County of San Diego  
Department of Planning and Land Use  
**BUILDING DIVISION**

**ACCESSIBILITY CORRECTION LIST**

Multifamily Housing

**Drinking Fountains**

**CBC FIGURE 11A-1H(b) – ALCOVE MANEUVERING SPACE**

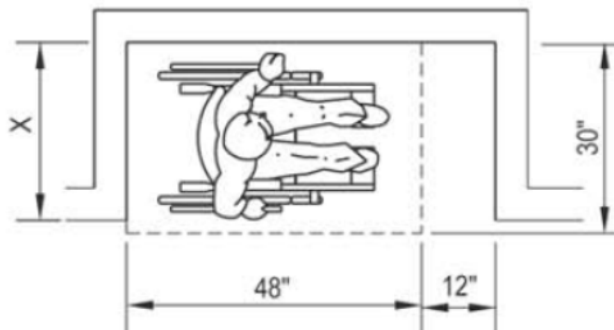
4. Dimension minimum 32-inch-wide by 18-inch-deep drinking fountain alcoves per CBC Figure 11A-11A(a).  
**Exception:** Minimum 32-inch-wide by 18-inch-deep wing walls per CBC Figure 11A-11A(b) acceptable if extending to within 6 inches of floor  
**Exception:** Additional width required at alcoves or wing walls with depth greater than 24 inches per CBC Figure 11A-1H(b)  
*CBC 1139A.3.1*
